Re: Design Professional review IID – 19-08

The Baffert at 5 Points

Re: Response to COT Design Professional Review for the Baffert at 5 Points

Re: Design Professional review 2 comments for the Baffert, IID-19-08

DEVELOPMENT PACKAGE for THE BAFFERT AT FIVE POINTS landscape enlargement plan

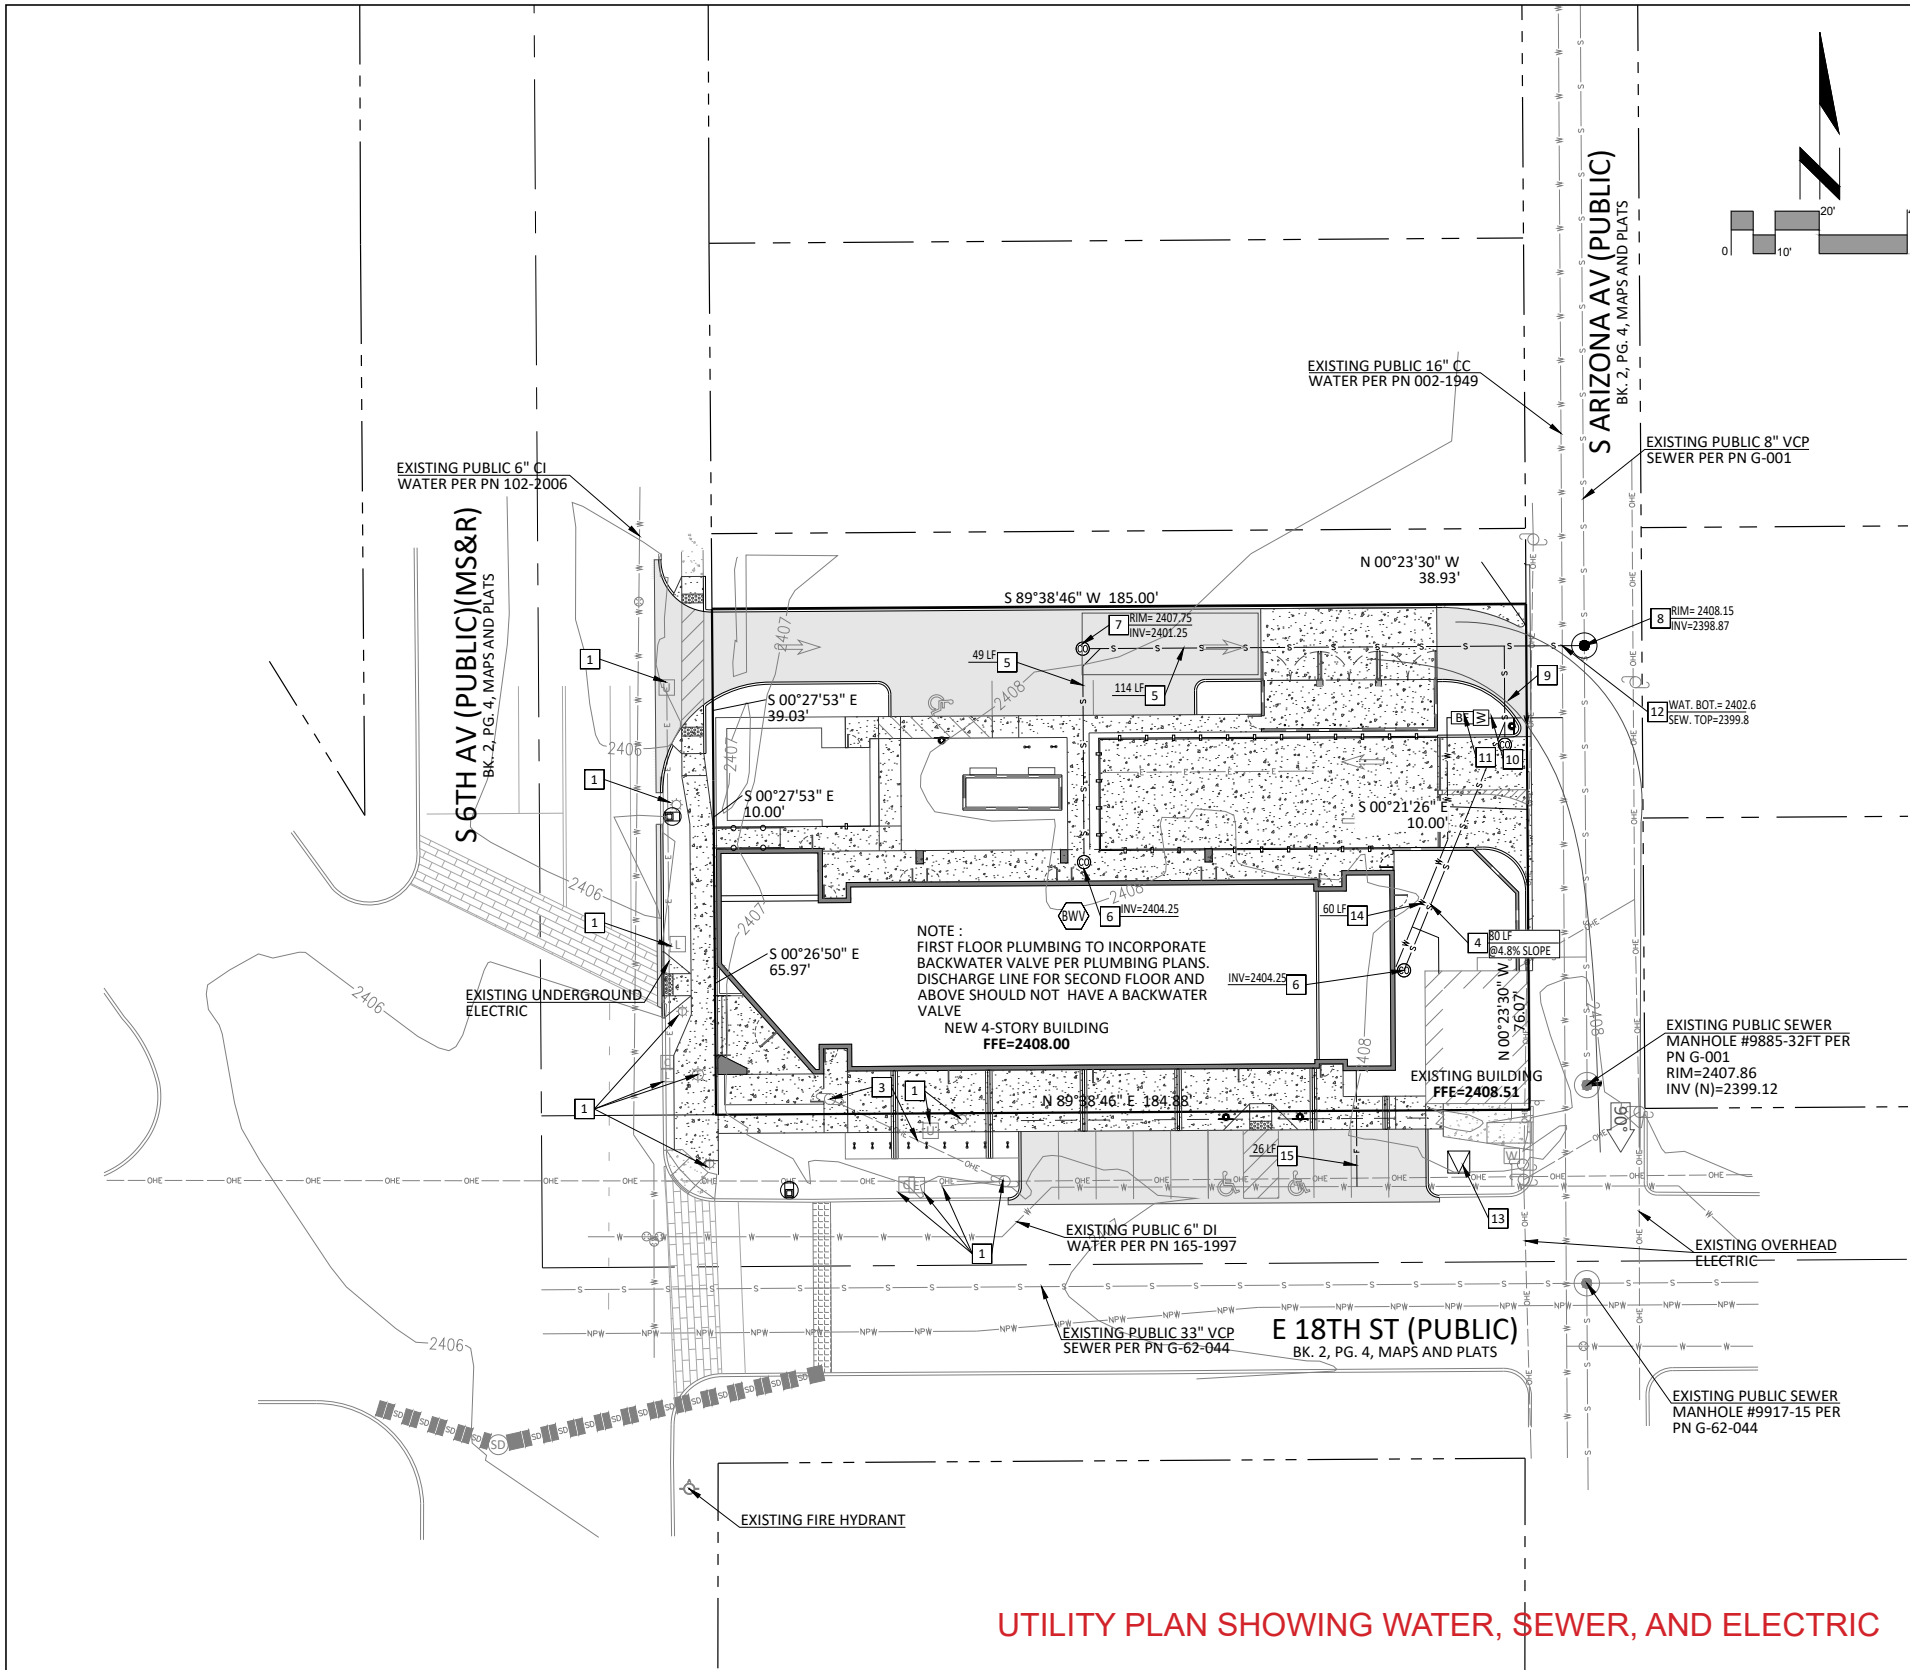
8. Show the location of bicycle parking spaces. (5.12.9.C.2.a)

3. Consider breaking the building mass on the east side to make it less imposing to the adjacent residential properties. (5.12.8.B.b)

4. Consider using additional landscape screening/buffers facing the adjacent residential properties to the east. (5.12.8.B.1.f)

Response: The current design considers that the existing carriage house will act as a major change in mass as the Baffert relates to the neighborhood. This reduction of mass and softening of the visual impact of the building will be further enhanced by 6' tall screen walls along Arizona Avenue, as well as major shade trees within the carriage house's patio and near the parking garage entrance. Additionally, the landscape plan includes lower scaled shrubs and planting elements to enhance the street level experience. We believe the current design responds well to considerations outlined in 5.12.8.B.2. An enlarged landscaping plan is attached for your review.

Response: Refer to the enlarged landscape plan for proposed bicycle parking locations. In addition, long term storage shall be provided within the residential dwelling units. Bicycle parking spaces have been provided in excess code requirements and per 5.12.9.C.2.a
